Gethsemane Redevelopment Project
DPD Project #3009393
Design Review
June 22, 2010

Site Planning & Massing

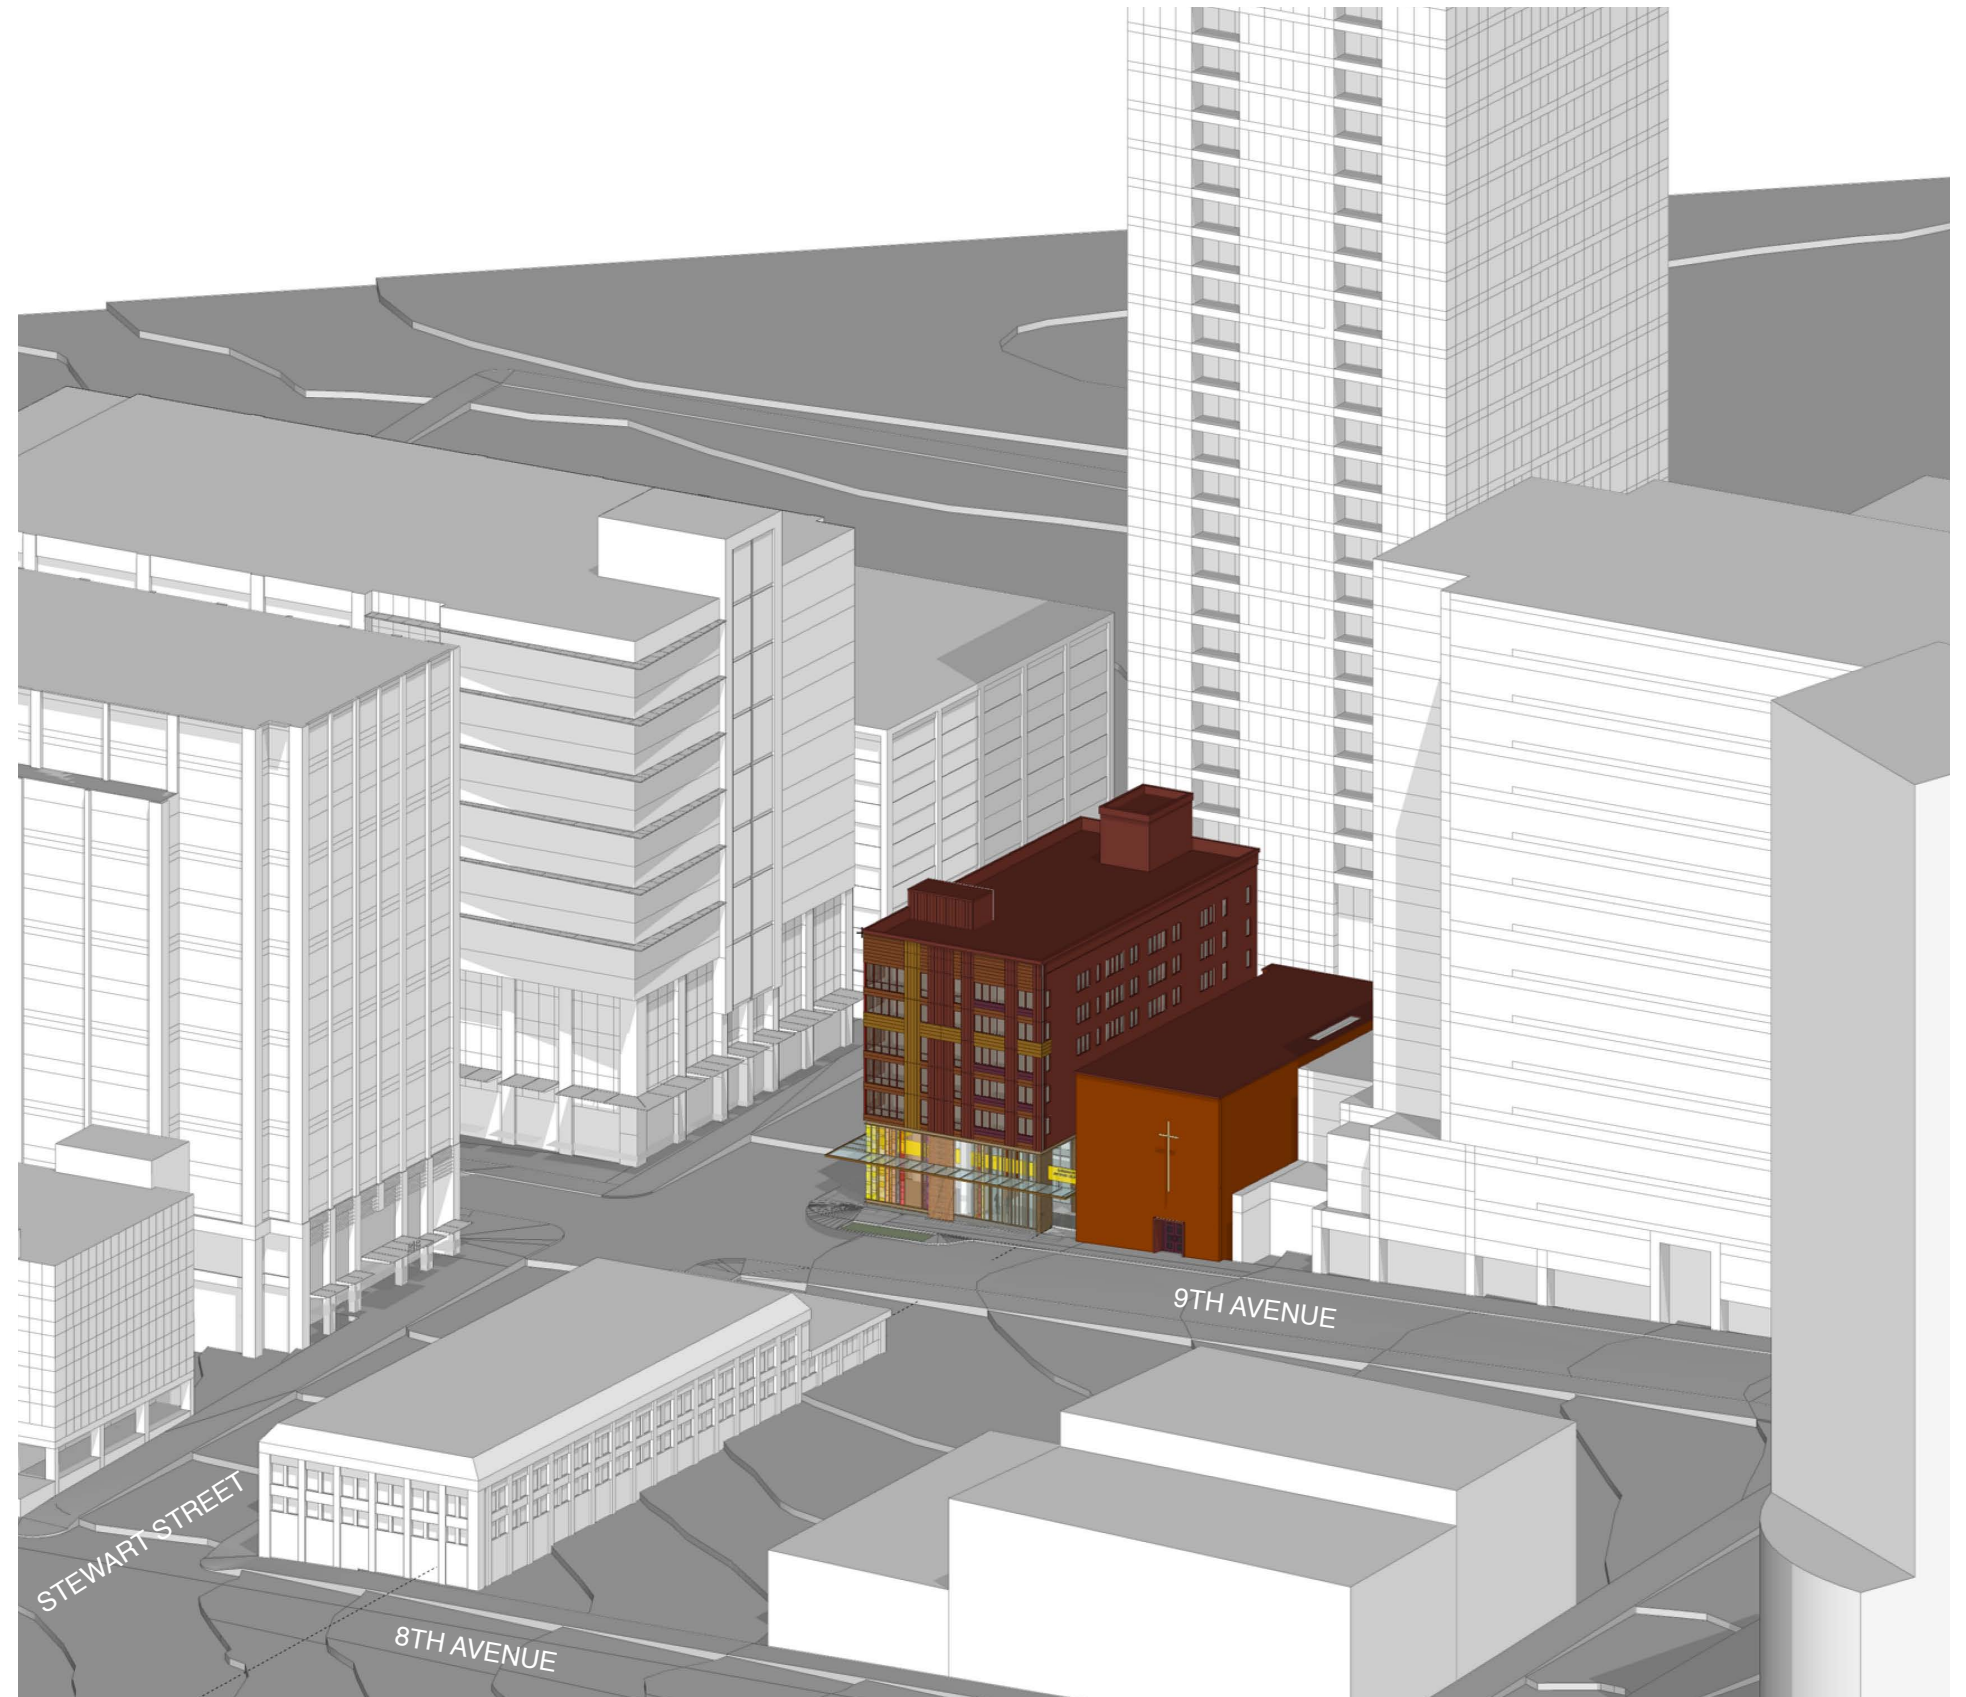
The proposed development would be the “small kid on the block,” and future design development should clearly demonstrate how the design holds its own within its context.

The building will always be the “small kid on the block,” but its strength will be that it’s different from its larger neighbors. Strong, rich colors in a large-scale pattern, a beautiful, similarly patterned roof visible from taller neighboring buildings and lush plantings spilling out from the church gardens to the green street plantings will give the building a strong character. Together with the existing sanctuary, the new structure will form a refreshingly human-scaled compound in a high-rise neighborhood.

VIEW LOOKING NORTH ALONG 9TH AVENUE

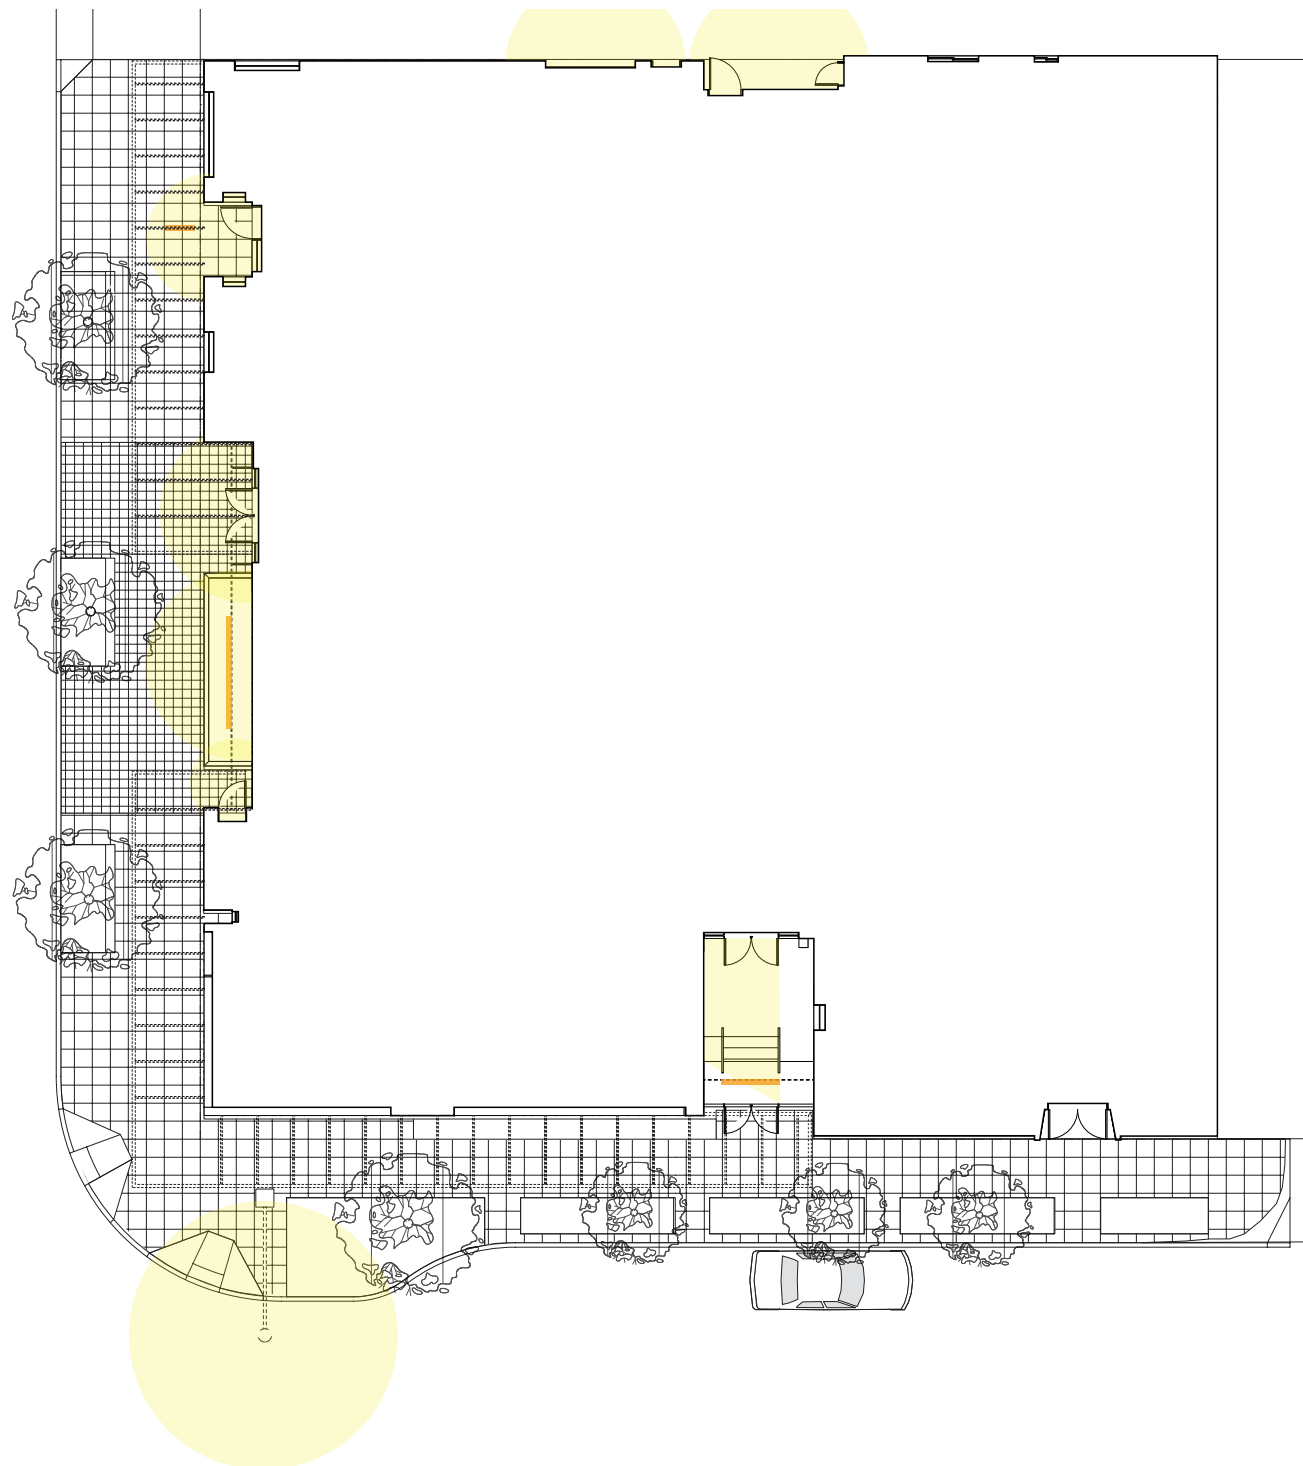
EDG Board Comment: The “garden” off 9th Avenue provides a golden opportunity to provide a special downtown space.

The proposed design has “garden” elements at both its Stewart Street and 9th Avenue facades, as well as providing enlarged curbside planting beds at both streets and a new landscaped curb bulb on 9th Avenue. At the time of the EDG meeting, the design team was contemplating requesting a departure for the green street setback on 9th Avenue. However, the landscaped setback at the building edge will strengthen the connection between the church garden, which is slightly above sidewalk grade, and the enlarged sidewalk and curb bulb planting beds proposed on 9th Avenue, creating a larger garden view for those in the garden, and a sense for pedestrians that they are walking through a garden, rather than alongside one.

The proposed project has many elements that will create a memorable “sense of place”: the relocated statue of Jesus and campanile cross providing a strong, familiar presence, the glowing multicolored chapel walls forming a beacon on the corner, the landscaping extending from the quiet church garden across the sidewalk to the enlarged green street planting beds to form an encompassing sense of a garden in the city.

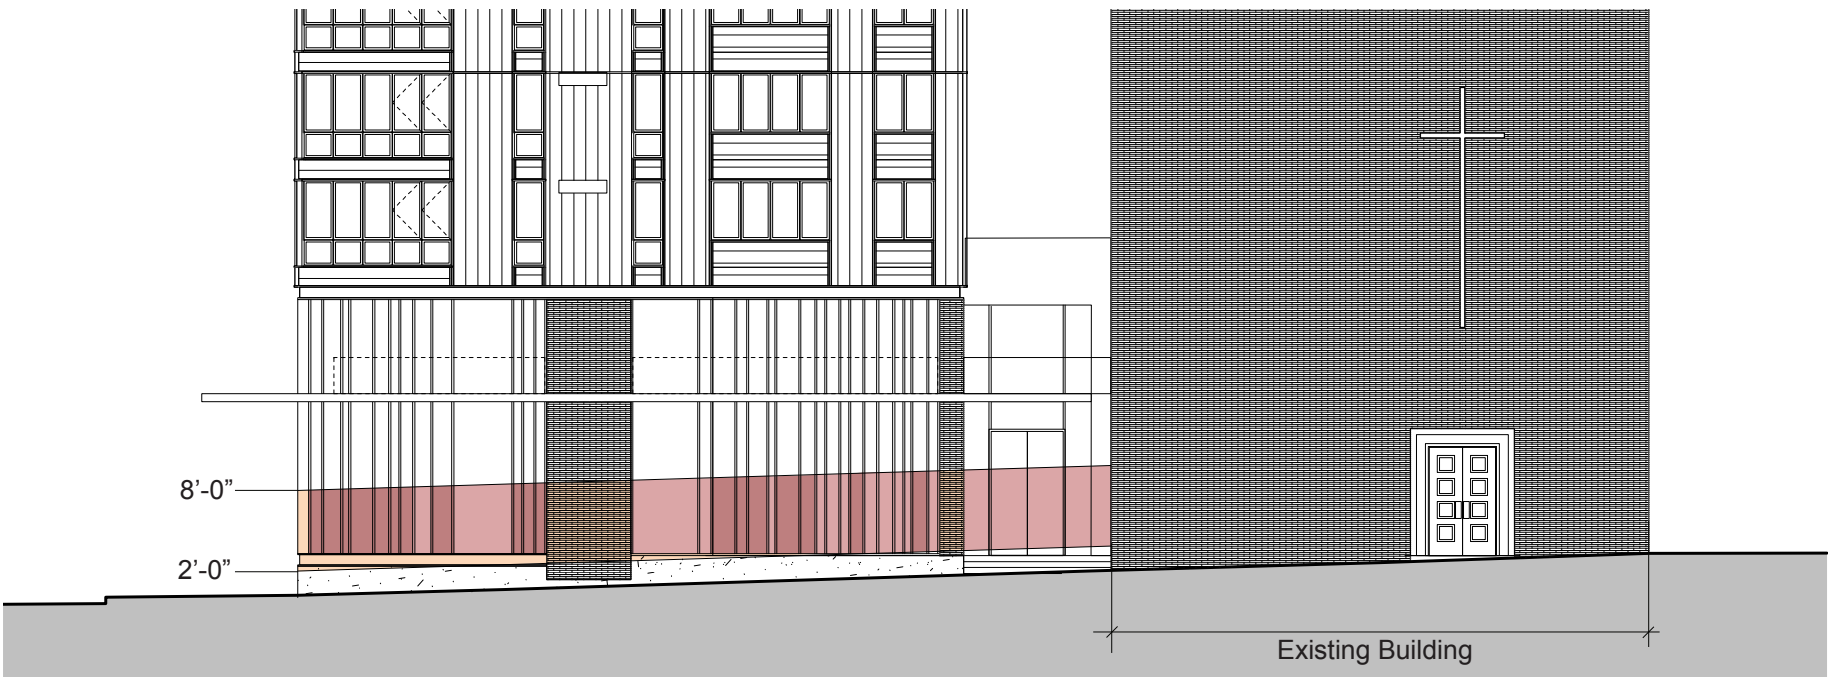
The board has not previously reviewed this departure request.

On both Stewart Street and 9th Avenue, the majority of the façade in non-residential use is a storefront glazing system or openings to the 9th Avenue garden. However, some of the storefront system will have colored glazing – stained glass – behind the storefront glazing. While much of the colored glazing will be lightly tinted, some sections of glass may be dark enough to limit views into the building interior.

The proposed departure is to provide a minimum of 60% of the street level façade area in storefront glazing or openings to the garden, allowing up to 20% of that storefront or opening area to have darker tinted glazing.

VIEW LOOKING SOUTH ALONG 9TH AVENUE

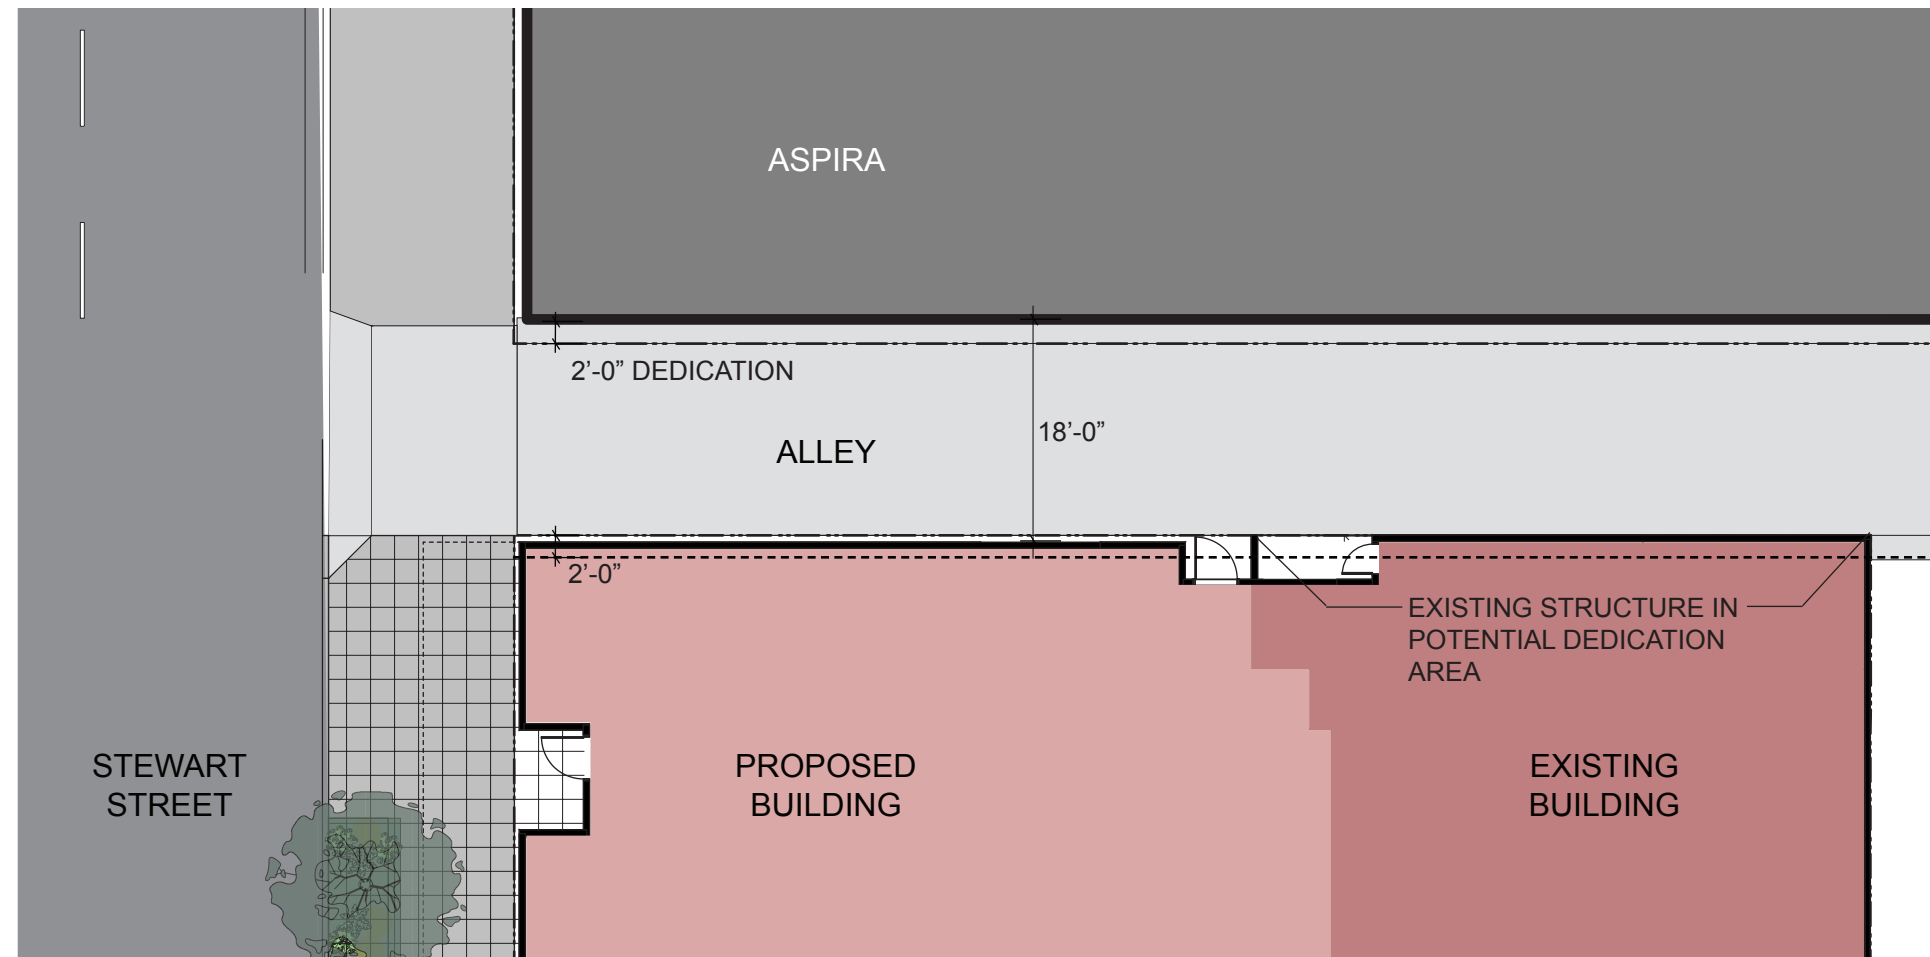
The board offered positive feedback regarding the green street façade setback departure request along Stewart Street.

Proposed Departure: The departure requested is to omit the upper level façade setback on 9th Avenue.

The departure requested better suits the neighborhood context, as it continues the strong street wall, higher than 45 feet, created by the existing adjacent buildings along 9th Avenue.

In a 70-foot-tall structure, a 15-foot façade setback at 45 feet above grade would create an awkward massing. The proposed departure better meets the intent of this guideline.
